STATE OF COLORADO

DIVISION OF RECLAMATION, MINING AND SAFETY

**Re: Evans #2 Pit, File No. M-2000-041,
Third Adequacy Review for Amendment 1 (AM-01)**

Figure 1. Elevations & Areas needed for BOND ESTIMATE.

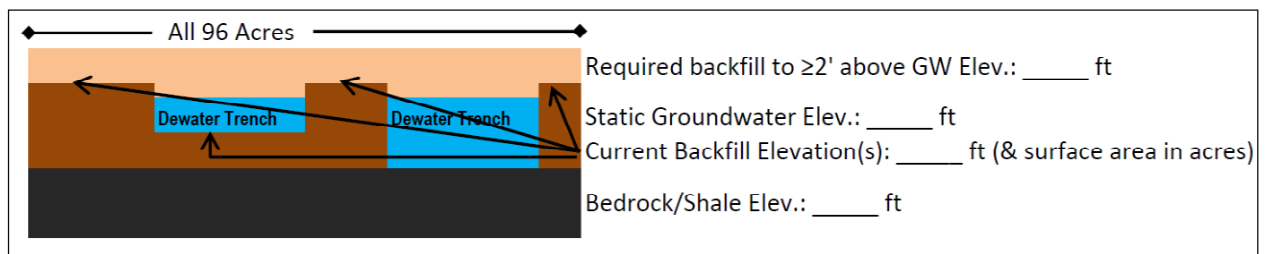
1. **Previous Items #13 and 13.a:** Item #4 in the Response to Second Adequacy stated approximately 700,000 cubic yards of material are currently available for backfill. As no information has been provided as to the current backfill volume or elevation in Phase I parcels 2 and 4, the Division must assume these are excavated to bedrock for the purpose

of estimating the required bond. The combined area of Parcels 2 and 4 is 105 acres (9+96, respectively). Assuming 22 feet of fill is required for all 105 acres, the Division estimates 3,726,800 cubic yards (CY) of fill are needed. If the site has only 700,000 CY available for backfill, approximately 3 million CY will need to be imported for backfill. The Division is currently assuming \$4.00/CY to import and place fill. This unit cost is based on typical costs, given the uncertain travel distance for imported fill material. The estimated cost just for the imported fill is just over \$12 million. Based on previous inspections the Division knows some backfill has been completed in Parcel 4 and not all of Parcel 2 was excavated. However, the depth and areal extent is unknown to the Division. As previously requested in our January 9, 2014 second adequacy review, please provide elevations for both parcels as shown in **Figure 1**. Otherwise the bond increase for interim reclamation may be significant. Please provide the following:

- a. Pit floor and current backfill elevations, and non-dewatered static groundwater elevation. This will information ensure the appropriate volumes are considered for the interim bond calculation.
- b. The Operator has committed to placing six inches of topsoil. Please also provide information on the currently unused/available topsoil/growth media.
